PART 5: Development Presentations

Item 5.1

Ref: 19/02988/PRE
Location: 443A Brighton Road, South Croydon, CR2 6EU
Ward: Purley Oaks and Riddlesdown
Description: Proposed redevelopment of the site to provide a residential led, mixed-use development comprising 75 residential units (C3) and 338sqm GIA of flexible commercial space (B1b, B1c and D1), with building heights ranging between 4 and 7 storeys, associated parking and landscaping, and all necessary ancillary and enabling works.
Applicant: Mr N Lawrence, Ironwood Works
Agent: Ms Lucy Howes, Icen Projects
Case Officer: Samantha Dixon

Figure 3. Proposed site layout plan

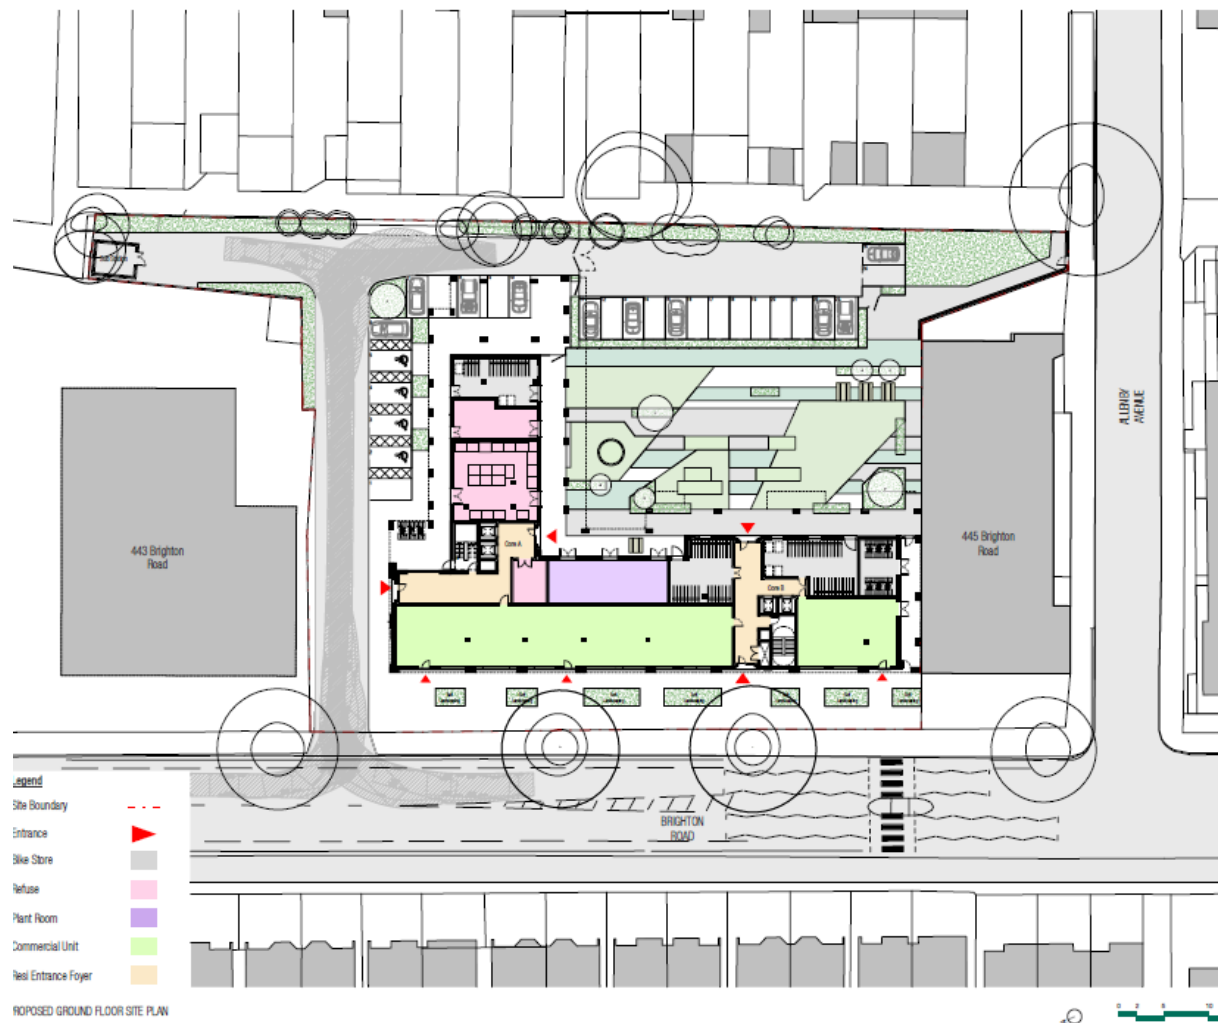
- The building line of the development should be set back to line up with the historic building line and give the important existing street trees the space they need to grow.
- The proposed height requires further townscape justification. Additional height may be acceptable.
- Public access into the development is not recommended.
- The colonnade at the front of the development is not acceptable.
- The stepping in of the south-western corner is not supported.
- There needs to be more certainty regarding the viability of the proposed commercial use of the ground floor. Maisonettes may be a more reliable way of ensuring active frontages.

- The development should be extended closer to the northern boundary.
- Exploration of relocating the car-parking along the northern frontage to the rear of the development.
- A continuous footway along Brighton Road is necessary.
- The entrances should be more prominent
- The landscape strategy requires further development
- The roofscape design requires development

- 6.30 Brighton Road has a wide footpath to the front of the buildings which contains mature and attractive street trees. As initially submitted, the proposed front building line sat forwards of the established historic building line and encroached into the canopy of the trees. The PRP were strongly of the opinion that the development should be set further back to align with the existing building line to help integrate the development with the neighbouring development and give coherence to the street scape. This would also ensure the trees are retained with space to grow. The applicant has undertaken this amendment, the building now aligning with the adjacent buildings.

- 6.31 At ground floor level, a colonnade was initially proposed along Brighton Road. The PRP did not support this approach as there is no precedent for such a feature in the local context, the covered walkway would hide the ground floor commercial units of the building and could also attract anti-social behaviour. The

applicant has therefore removed the colonnade from the scheme. The commercial units directly front the highway creating an active frontage to the street scene as required by Policy DM10.11. It is considered that the frontage of the commercial units should be further developed to clearly distinguish between the commercial and residential uses with space for signage. The wide pavement would be retained and the public realm would be enhanced with soft landscaping planters.
